## **IMPORTANT RECALL INFORMATION #80311**

**SUBJECT: RECALL CAMPAIGN #80311  
2008 & 2009 PULSE AND ICON CLASS C MOTOR HOMES  
ENTRY STEP ATTACHMENT CRADLE/SUPPORT**

# Recall Bulletin 80311

**SUBJECT:**  
Replacement of  
Entry Step Cage

Figure 1

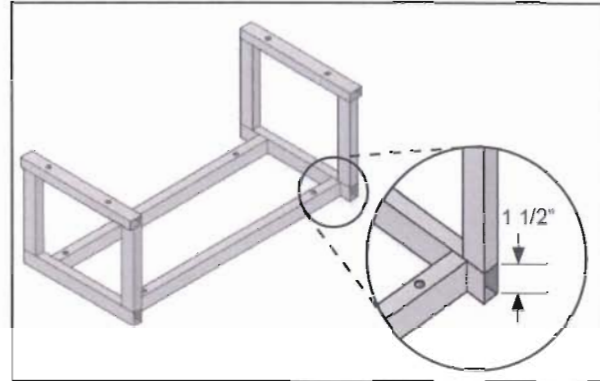
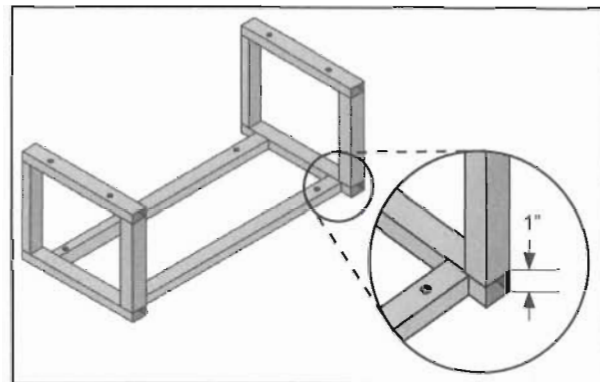
Insufficient welds on the entry step cage may allow the entry step to break away from its mounting location.

4. Locate the two horizontal rails of the entry step cage, which provide the bolting location for the entry step. The rails are positioned parallel with the pavement and consist of 1" X 1-1/2" tube steel.
  - A. If the horizontal rails are positioned in a tall configuration, 1-1/2" tall and 1" wide, no further action is necessary and this Bulletin is complete. See Figure 1.
  - B. If the horizontal rails are positioned in a flat configuration, 1" tall and 1-1/2" wide, proceed to the Correction section of this Bulletin. See Figure 2.

Incorrect Entry Step Cage - Step Cage Replacement Required

Figure 3

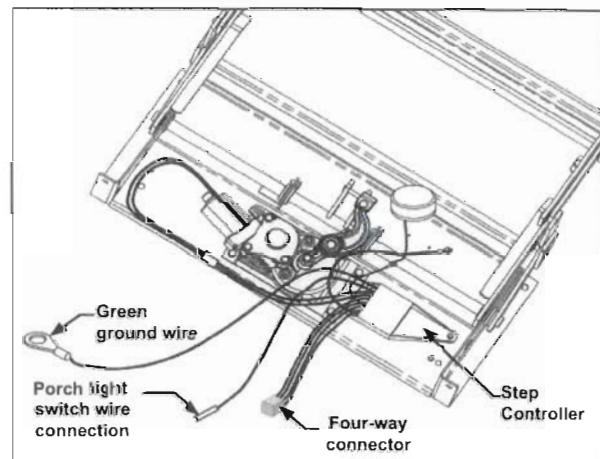
5. Unplug the four-way connector for the step controller and unplug the connector for the porch light switch wire. Refer to Figure 3.
6. Disconnect the entry step controller green ground wire from the motor home chassis frame in order to allow removal of the entry step assembly. Retain ground wire fasteners for reassembly.

Figure 4

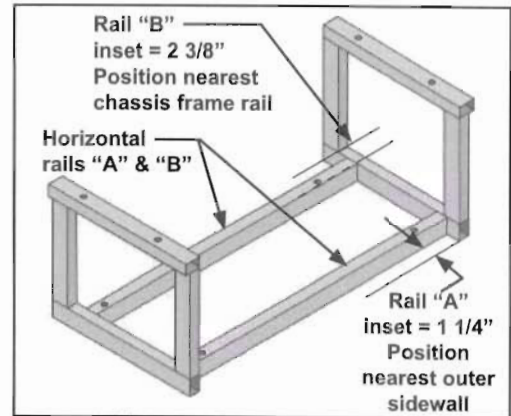
- Refer to Figure 4 to determine the correct installation position of the entry step cage:  
Rail "A" is inset 1 1/4" from the outer corner of the entry step cage. Position the step cage assembly so that Rail "A" is nearest the outside sidewall of the motor home. Rail "B", inset 2 3/8" from the opposite corner, upon installation should be nearest the motor home chassis frame rail.

- Position and install the new entry step cage onto the bolts extending through the floor that secured the original component. Install original washers according to the location notes from Step 8, and install new 3/8-16 locking nuts. Torque nuts to 25-30 ft-lbs.
